4-2 WIRE REPEATERS (J99343RB, RC, RG, RJ)
2-4 WIRE INTERMEDIATE REPEATERS (J99343RD, RE, RH, RK)

INSTALLATION AND TESTING
METALLIC FACILITY TERMINAL

1.001 This addendum supplements Section 332-912-221, Issue 3. Place this pink sheet ahead of Page 1 of the section.

Fig. 13—J99343RJ, RK Precision Balancing Network Switch Functions

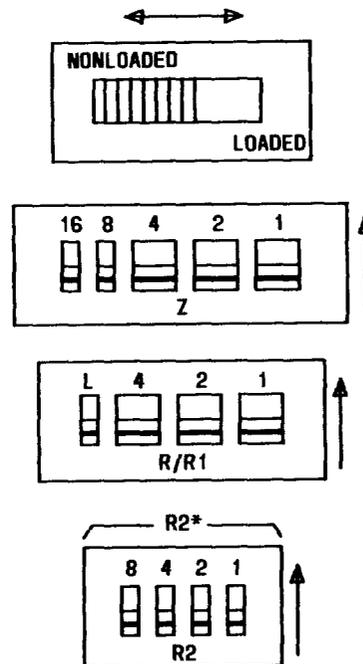
2.003 On Page 10, Fig. 13 is incorrect. A new Fig. 13 is shown in this addendum.

* R2 SWITCHES ARE NOT USED WHEN BALANCING LOADED CABLE. THESE SWITCHES SHOULD BE OFF.
